City of Seattle

STANDARD SYMBOLS  
PRIVATE UTILITIES

**POLYMER CONCRETE  
HANDHOLES**

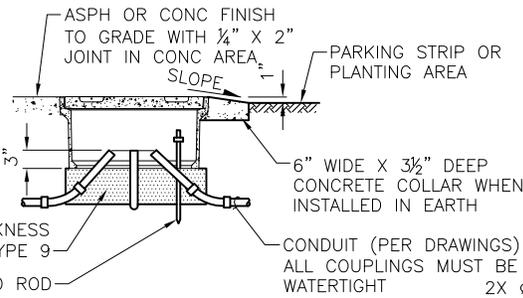
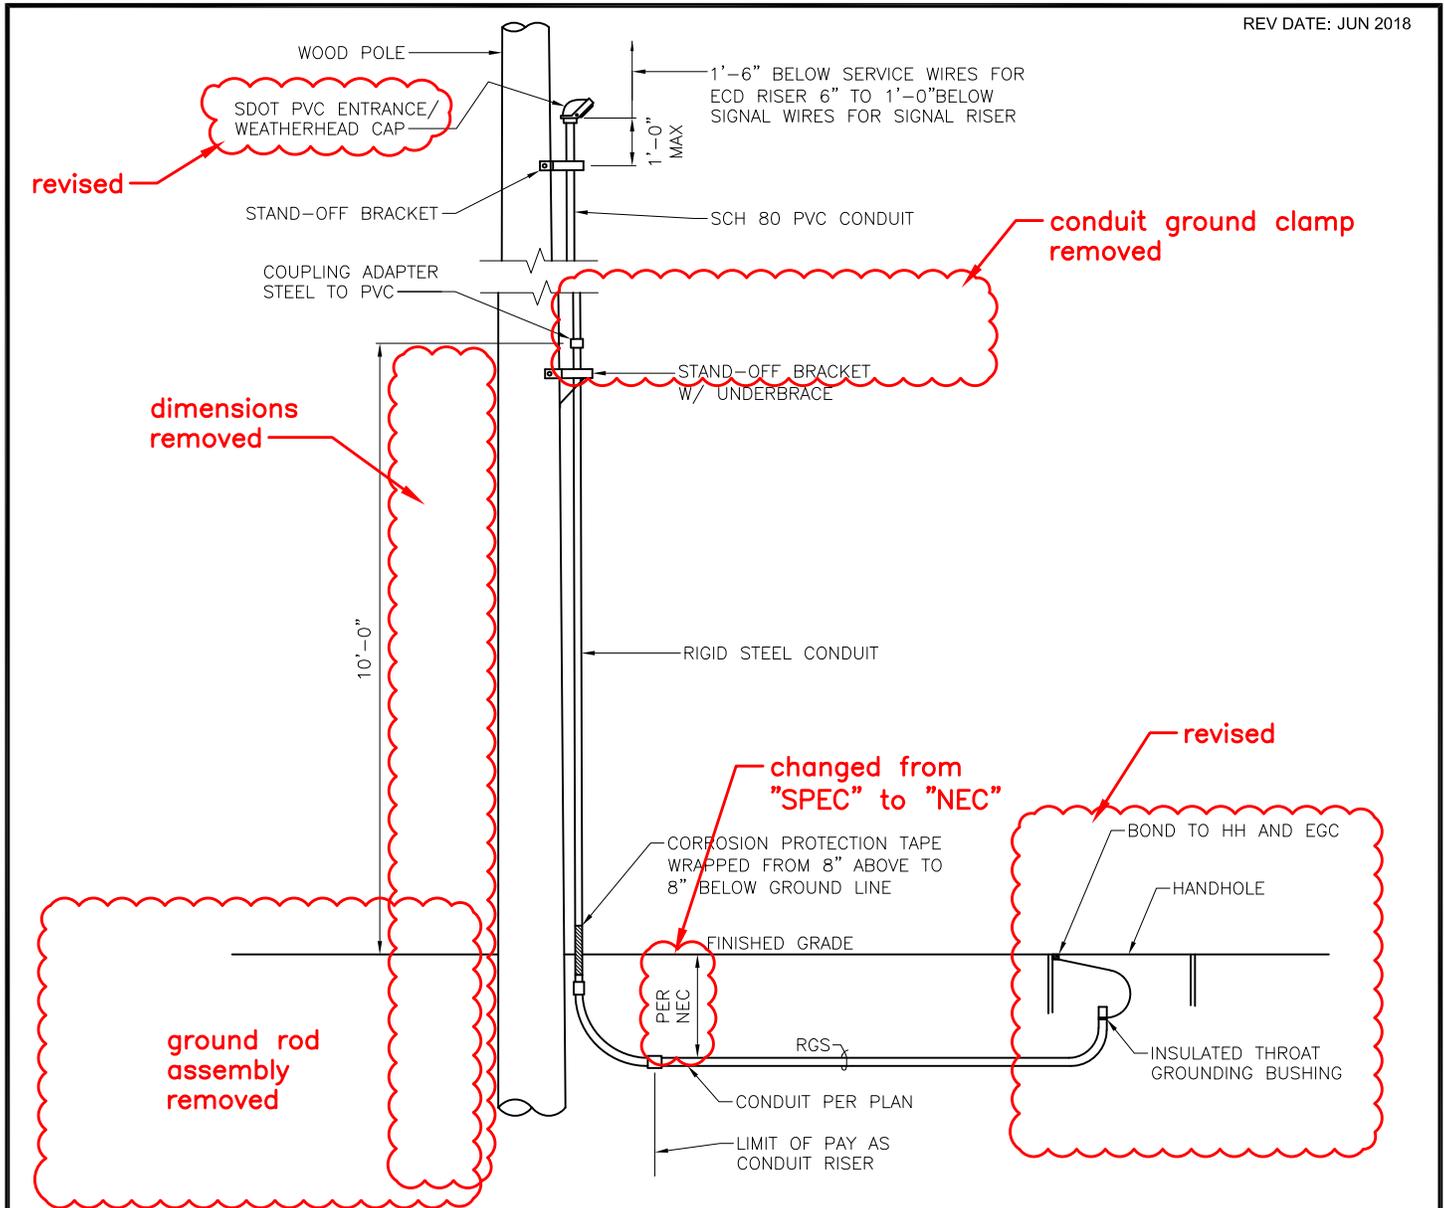
note revised

TRAFFIC CONDUIT RISER

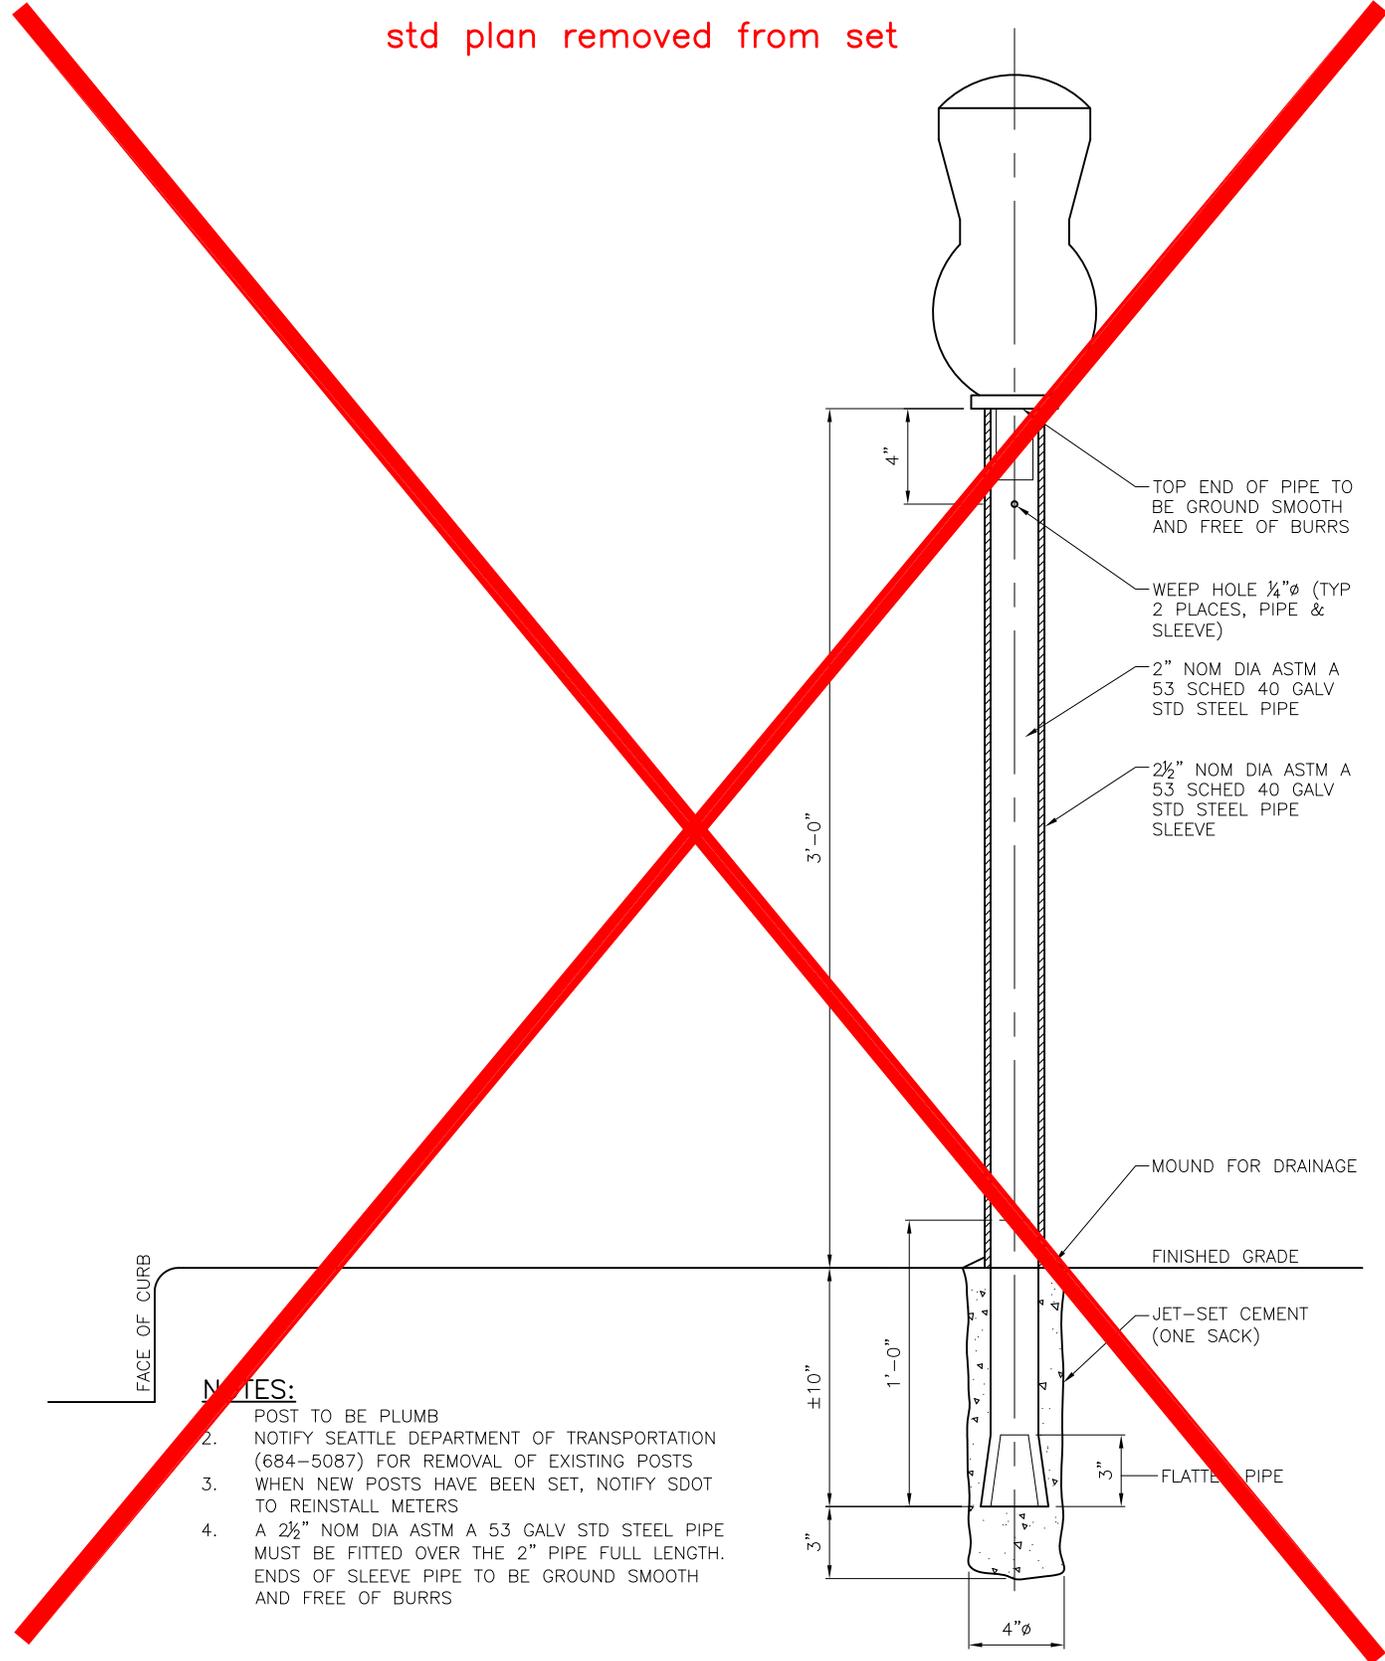
note 3 revised. previous note 5 removed and notes renumbered. notes 7 & 9 revised.

std plan removed from set

1. ON POLES WITH EXISTING CONDUITS, NEW CONDUITS MUST BE INSTALLED IN ACCORDANCE WITH THIS STANDARD PLAN.
2. RIGID STEEL CONDUIT MUST BE GROUNDED JUST BELOW COUPLING, APPROXIMATELY 8'-0" TO 10'-0" ABOVE GROUND, AS SHOWN
3. ALL RISERS BONDED IN HH
4. THE GROUND WIRE MUST BE ONE CONTINUOUS LENGTH. INSERT THE GROUND WIRE FORM THE BOTTOM OF THE GROUND CLAMP & BEND OVER THE CLAMP BEFORE TIGHTENING
5. ALL STEEL HARDWARE MUST BE HOT DIPPED GALVANIZED AFTER FABRICATION PER ASTM A123
6. CONDUIT CLAMP SPACING MUST BE PER THE NEC WITH A MINIMUM OF TWO HOLE CLAMP PER 10'-0" LENGTH OF CONDUIT
7. SERVICE AND SIGNAL CONDUCTORS MUST NOT BE PLACED IN THE SAME CONDUIT.
8. WHEN POSSIBLE, RISER MUST BE INSTALLED ON DOWNSTREAM SIDE OF TRAFFIC
9. SEE SCL CONSTRUCTION STANDARD 1714.50 FOR STREETLIGHT HANDHOLE AND CONDUIT REQUIREMENTS & 0224.34 FOR STREETLIGHT CONDUIT RISERS.

PEDESTRIAN WAY  
FINDING SIGN

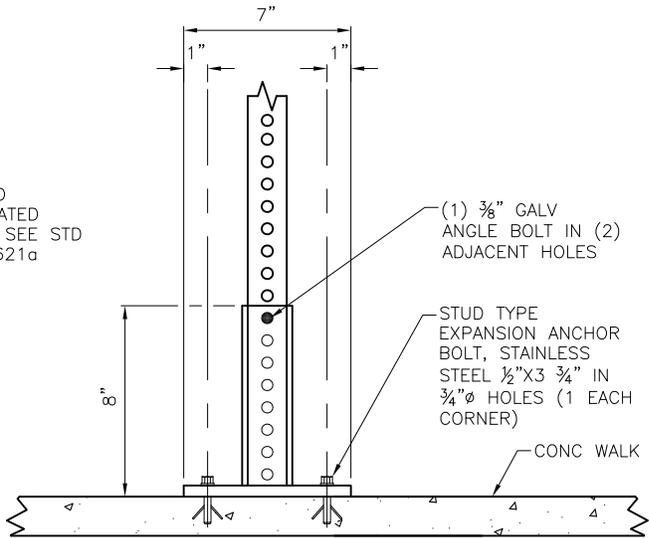
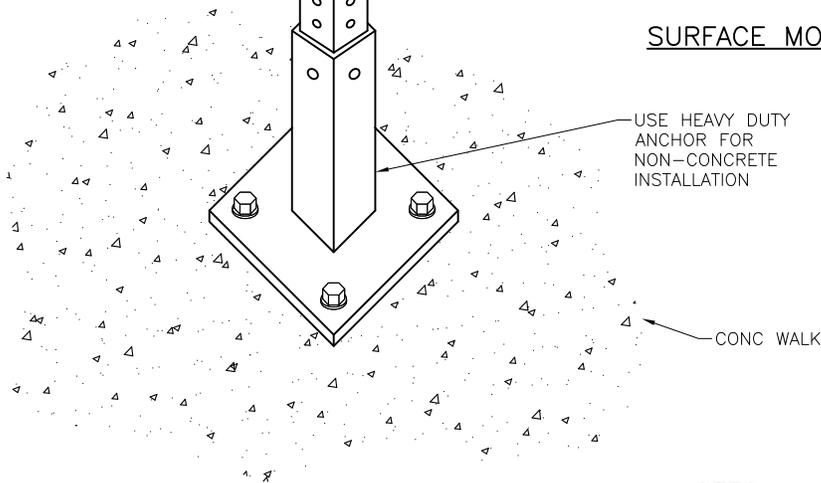
spec sec added
